# Representation - Draft Modification Report UNC 0826S Amendment to Network Entry Provision at Shell St Fergus Terminal

Representative:	Martin Cahill
Organisation:	National Grid
Date of Representation:	02/12/2022
Support or oppose implementation?	Support
Relevant Objective:	a) Positive d) Positive
Relevant Charging Methodology Objective:	Not Applicable

Figure 1 Flow Diagram

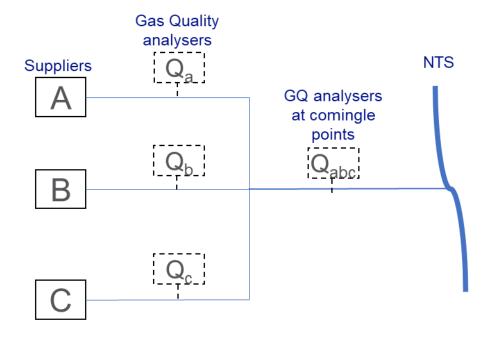
The key safety measures used in the TFA process are as follows (please also refer to figure 1 for a visual representation and reference points):

1. Gas from all 3 sub-terminals is commingled at the National Grid owned St Fergus asset\* before it reaches the NTS. This reduces the risk of any non-compliant gas on the network if a supplier is close to or above the specified Wobbe limit

- 2. A high value (before reaching a breach) on any Wobbe reading at Qa, Qb, or Qc will initiate a warning call from GNCC to the supplier, and a discussion as to the cause of the issue and expected resolution

- 3. A 15 minute warning is applied if there is a breach at Qa, Qb or Qc, provided that Qabc is within specification (Qabc is the commingled point which is representative of the gas which will be supplied to the NTS)

- 4. If a supplier is not back within specification within 15 minutes, curtailment action will be taken by GNCC to reduce flow
- 5. More immediate action will be taken by GNCC if there is a risk of a breach at Qabc

- 6. Monitoring of individual supply meters and commingled gas provides additional contingency for any monitoring error. National Grid also regularly calibrates equipment and investigates any discrepancies against supplier readings

- \* It should be noted that the Distribution Network Offtake at St Fergus also receives gas which has been commingled
